DEVIATION REQUEST AND DECISION FORM

Project Name :	Trails at Aspen Ridge Filing No. 4
Schedule No.(s) :	5500000412
Legal Description :	Unplatted Land

TRAILS AT ASPEN RIDGE			
FILING NO. 4 ROADWAY & STORM IMPROVEMENT PLANS			
STORM DRAIN PLAN & PROFILE			
DESIGNED BY:	JTS	SCALE	DATE ISSUED:
DRAWN BY:	BAS	HORIZ 1" = 40'	JUNE 2021
CHECKED BY:	NMS	VERT 1" = 5'	SHEET 26 OF 32
DRAWING No.			SD03

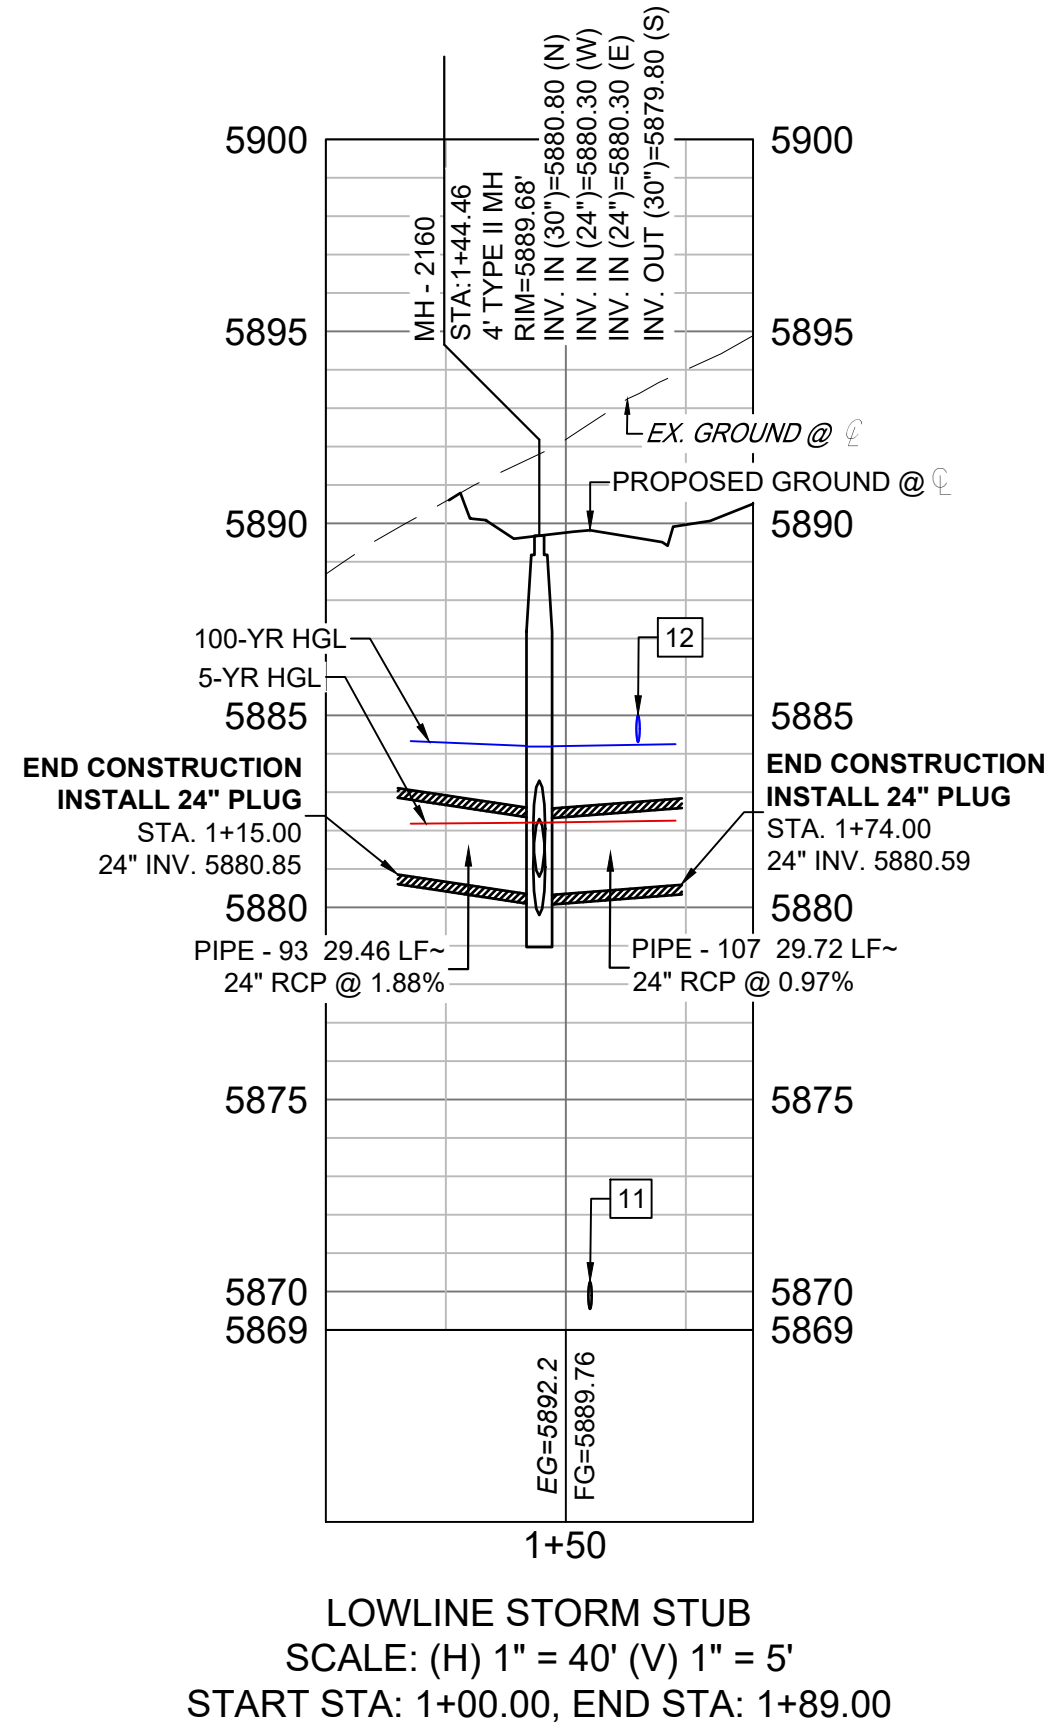
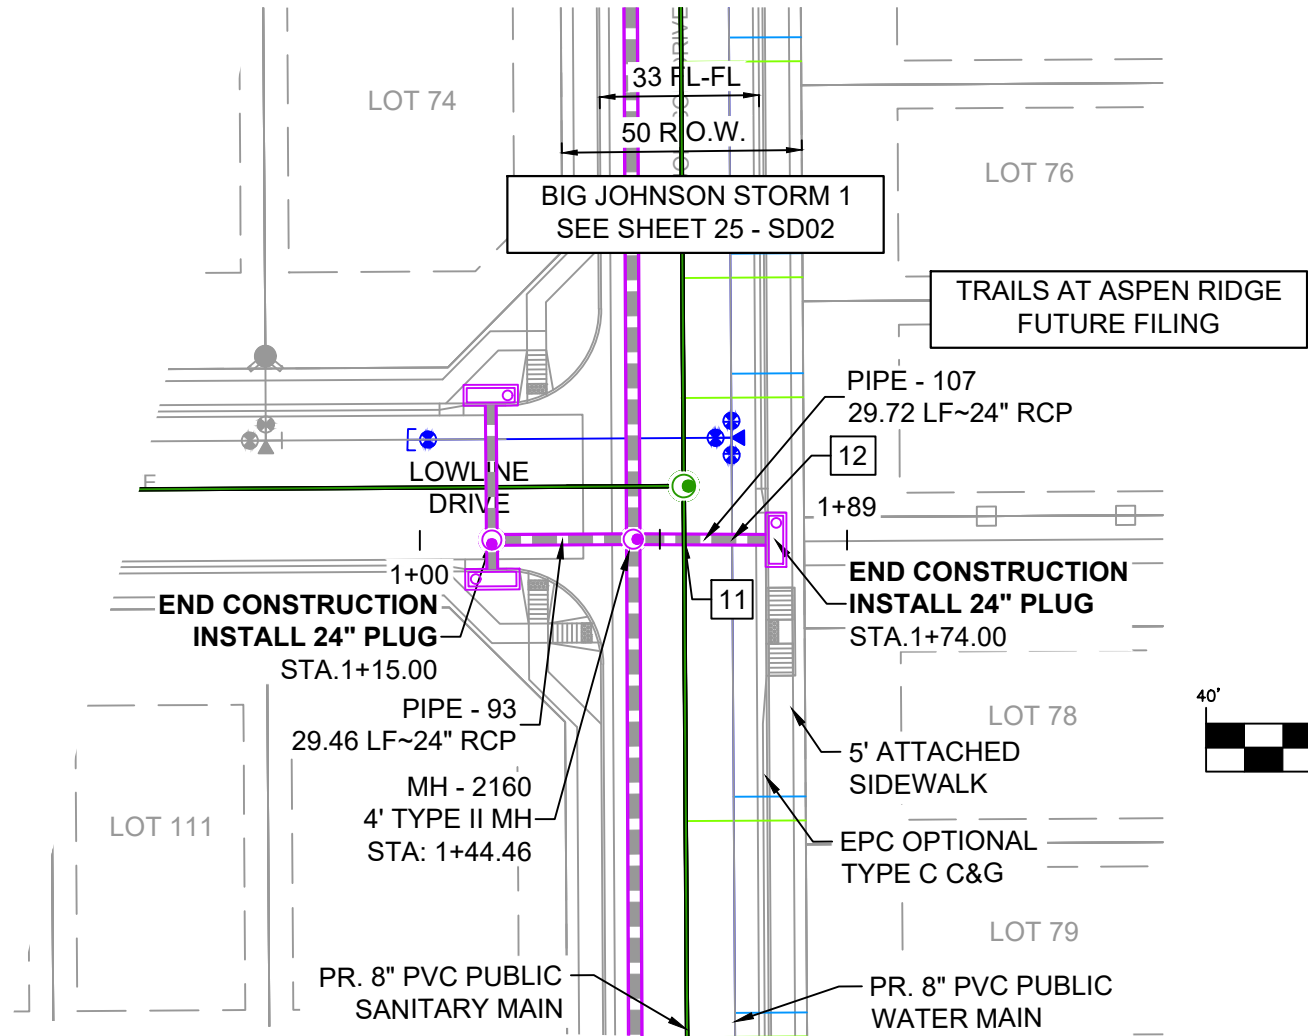
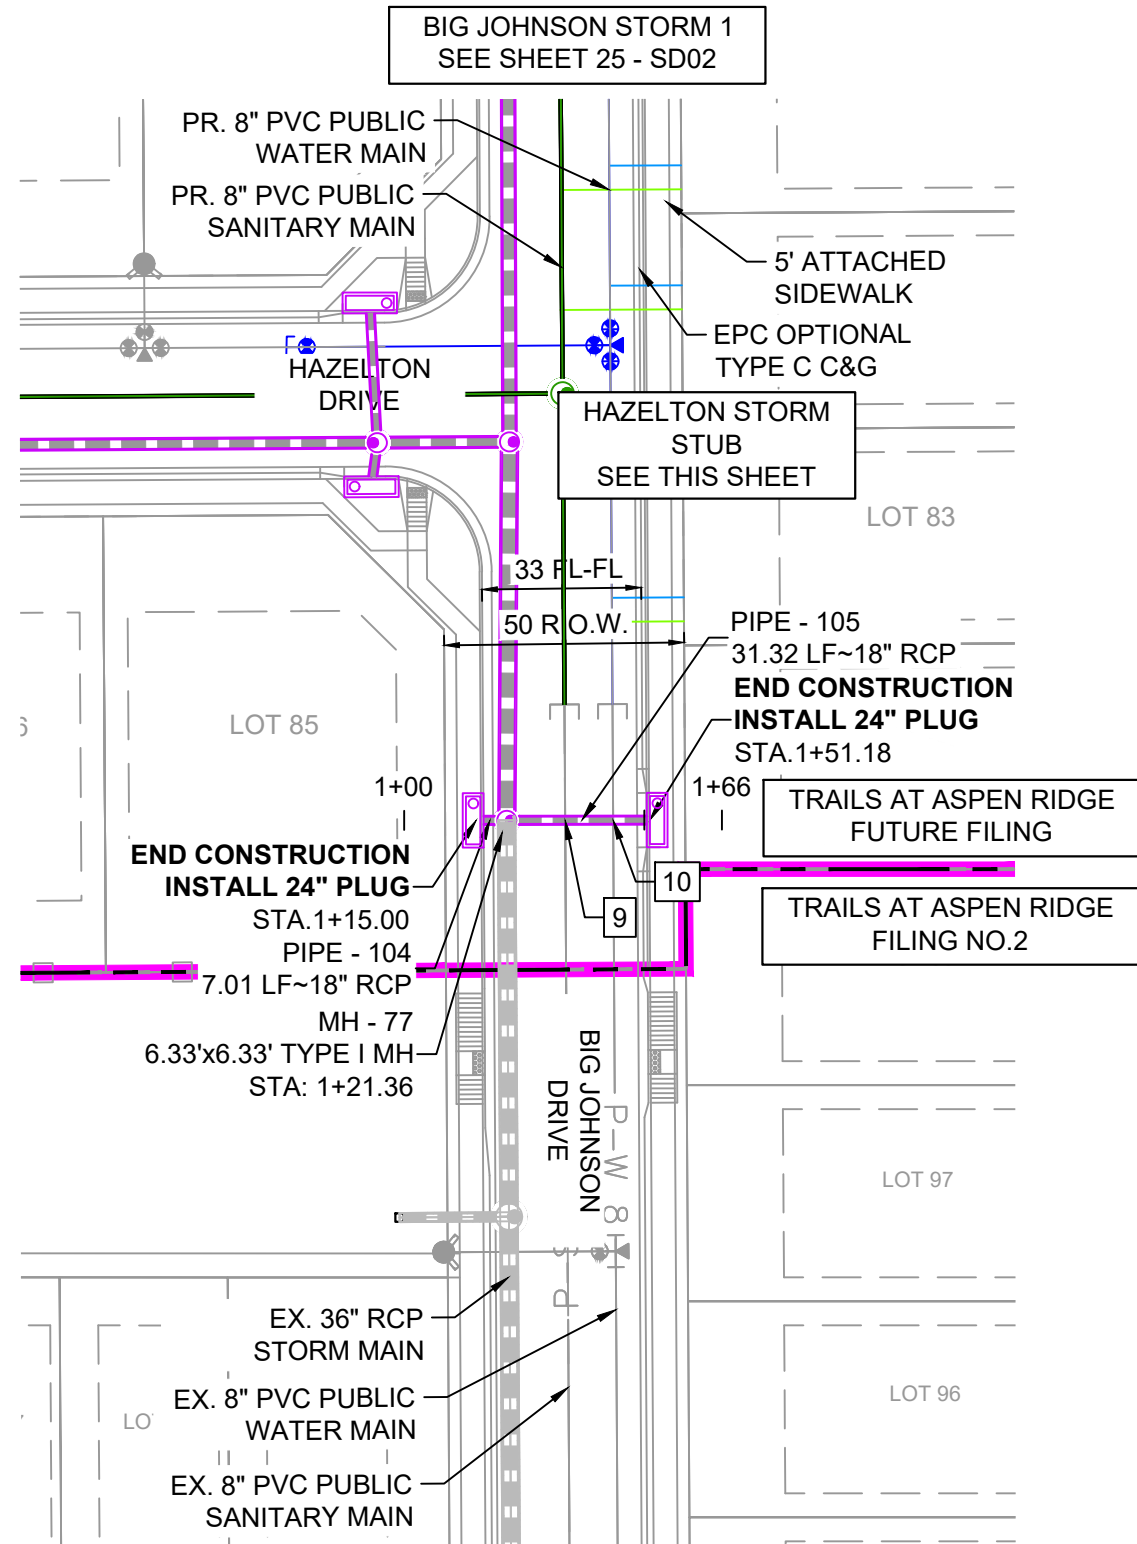
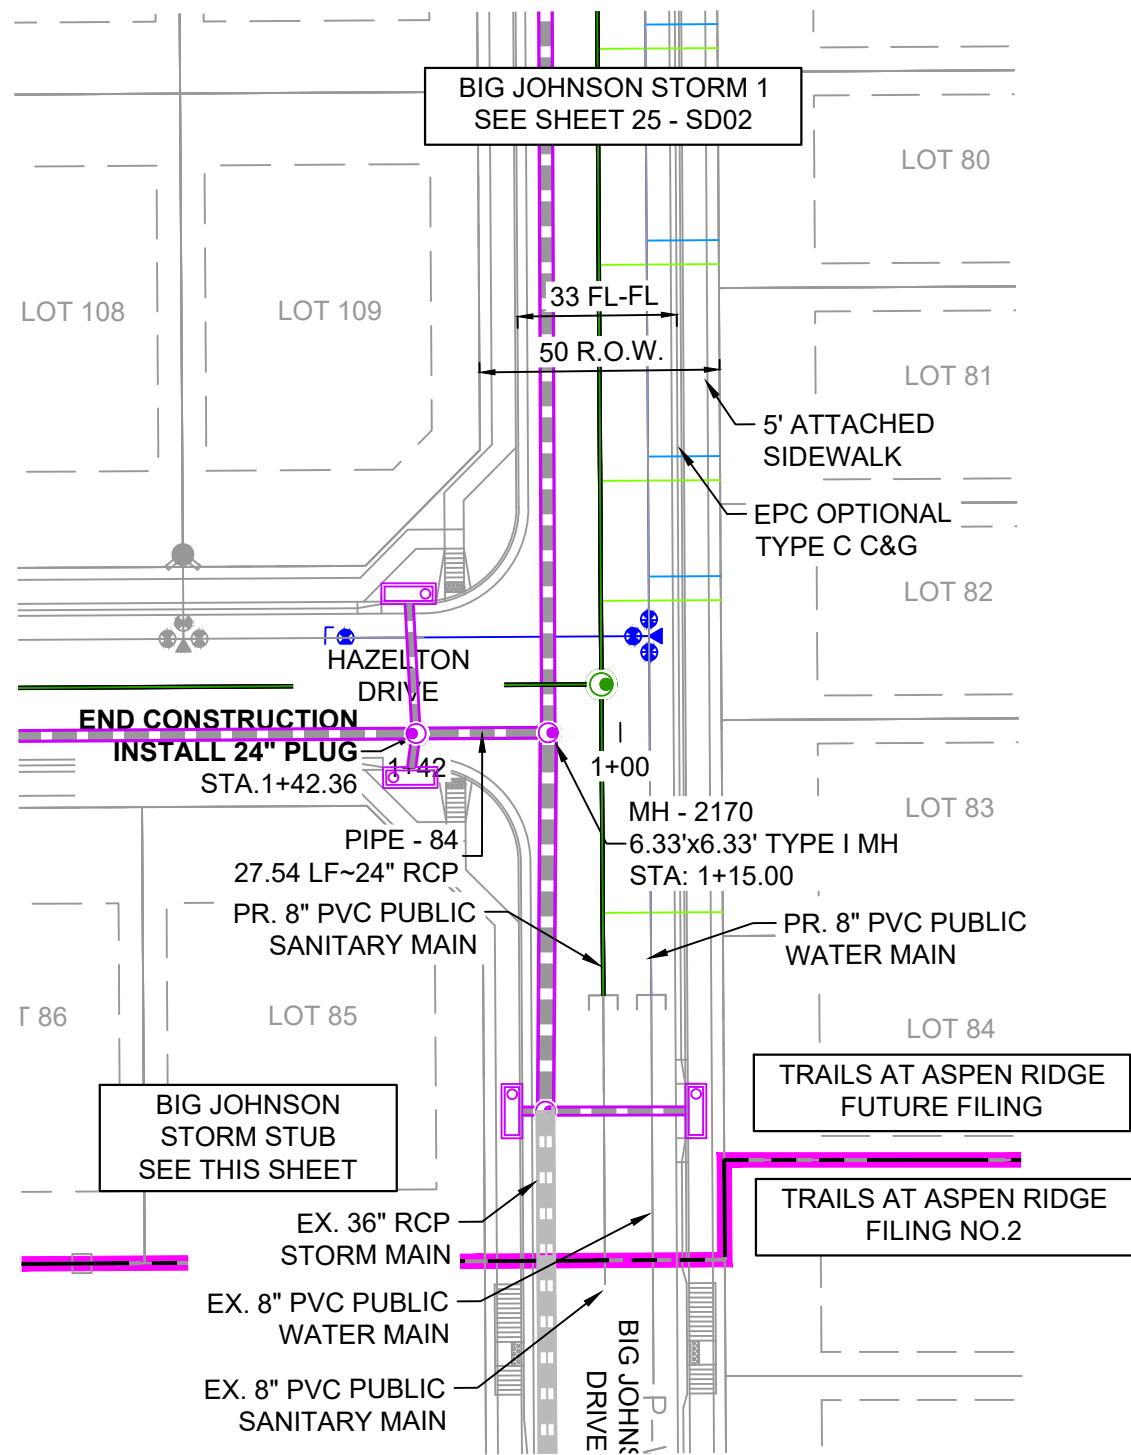
Storm MH-77: A manhole drop greater than one foot (without matching inside top of conduit elevations) is requested in order to provide clearance above the existing water main at this location. The drop manhole and associated inlet are vital components of the site design and enable more easily maintainable depths of cover and avoidance of the many potential utility conflicts within the site.

Drop manholes in excess of 1-ft have been approved under the City of Colorado Springs DCM Volume 1, Chapter 9, Section 6.4 (regional standard) for similar situations within adjacent municipalities. Drops greater than 1-ft require additional concrete strength and scour protection which is proposed with this design in the form of Class S35 concrete for the manhole and provision of a 1' sump for energy dissipation.

By raising the upstream storm pipe to avoid utility conflict with the existing water main, and by lowering the downstream pipe to reduce pipe velocities/HGL's to within acceptable range, the 6.13-foot drop meets the design intent and purpose of the ECM standards.
